First Amendment to the
Draft Environmental Impact Report
550 E Brokaw Development

State Clearinghouse No.: 2021060414
File Nos.: H21-005/T21-005/ER21-018

October 2022

Figure 7.8a - Bus stop where bikeway is at the same level as the roadway

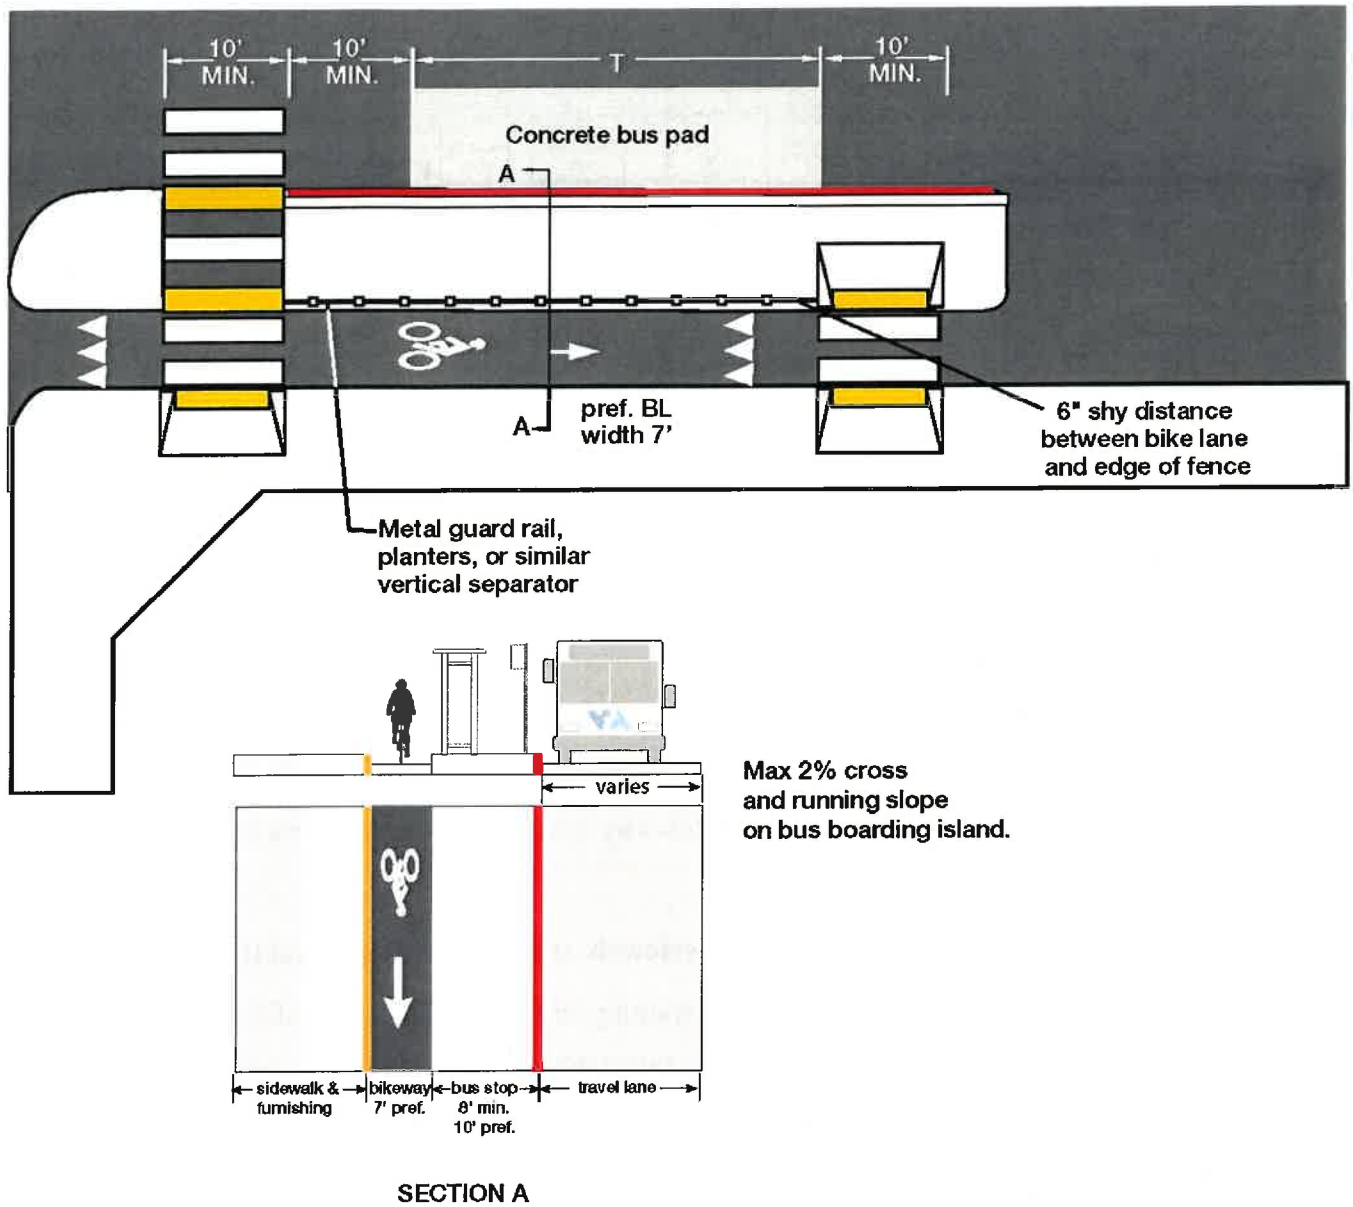
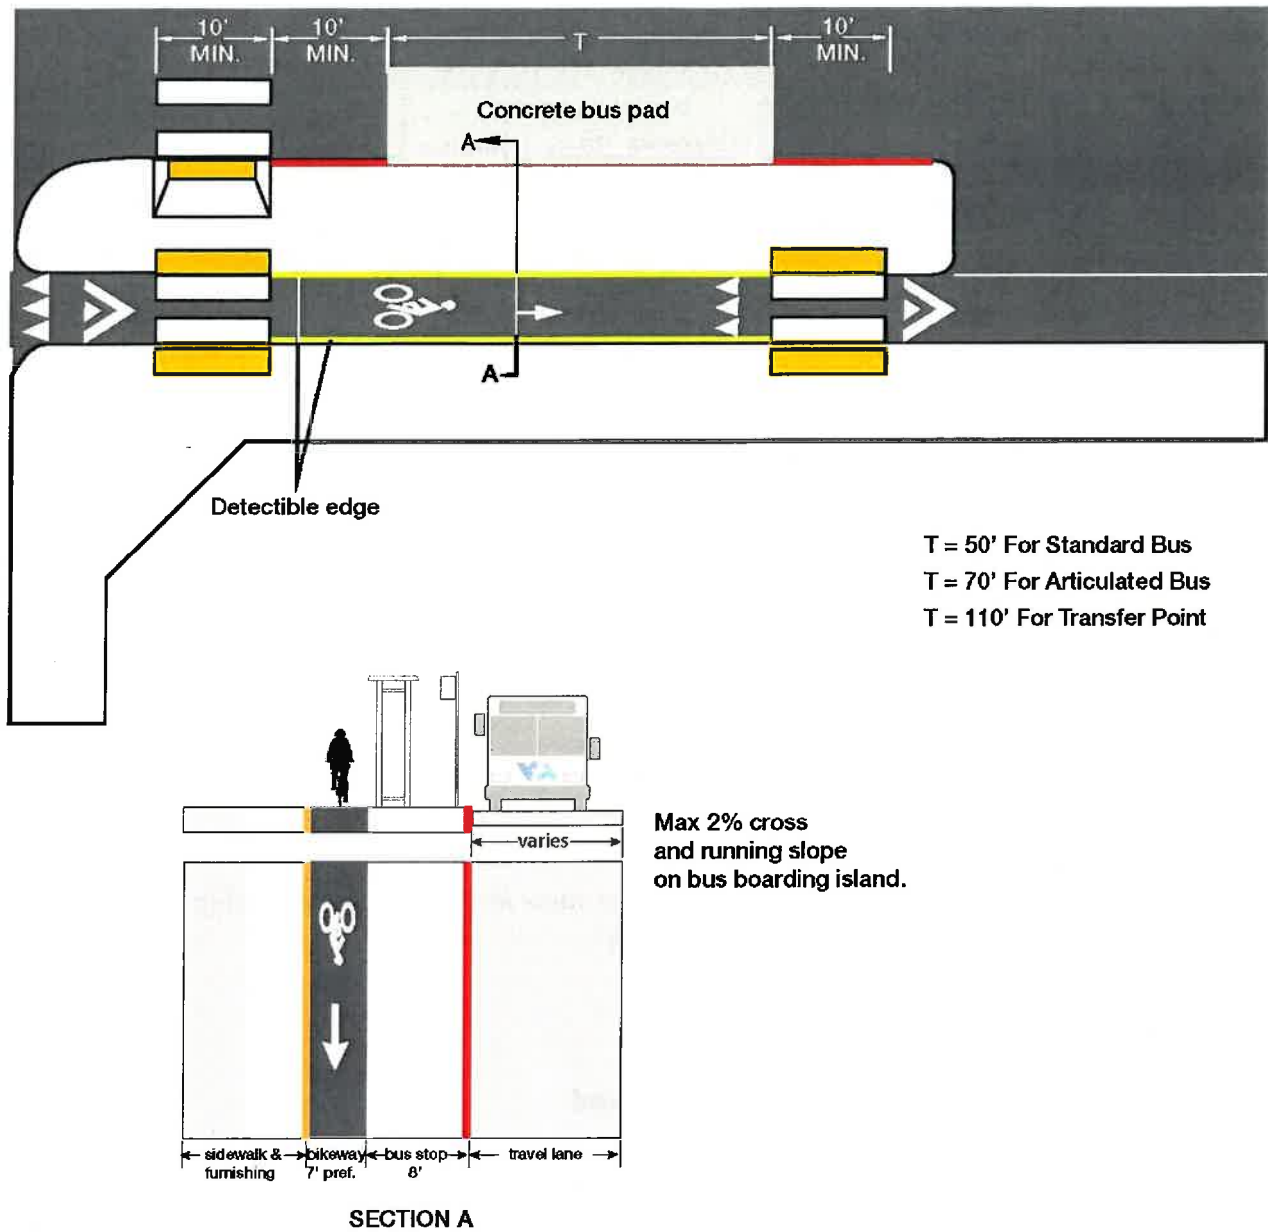
- With the construction of the protected bike lanes along the project frontage on Brokaw, VTA recommends that any bus boarding islands be built to VTA standards. VTA's Bus Boarding Islands memo with specifications is attached; Figure 7.8a and 7.8c is a bulb out design that closely matches past discussions between VTA and City staff.

- VTA supports the improvements listed in mitigation measure MM TRN-1.1 to connect the sidewalk on westbound Brokaw and relocate VTA's bus stop closer to the Brokaw / Junction intersection. The proposed relocated bus stop has a driveway nearby, so VTA requests that the City coordinate closely with VTA regarding the placement and design of this stop.
- With the construction of the protected bike lanes along the project frontage on Brokaw, VTA recommends that any bus boarding islands be built to VTA standards. VTA's Bus Boarding Islands memo with specifications is attached; Figure 7.8a and 7.8c is a bulb out design that closely

Response D.3: The City acknowledges receipt of VTA's Bus Boarding Islands memo. As discussed in Response D.2 above the project applicant is required under MM TRN-1-1 to coordinate the design of the bus stop including the bus boarding

island with VTA. This comment does not provide new information that would change the analysis or conclusions disclosed in the Draft EIR.
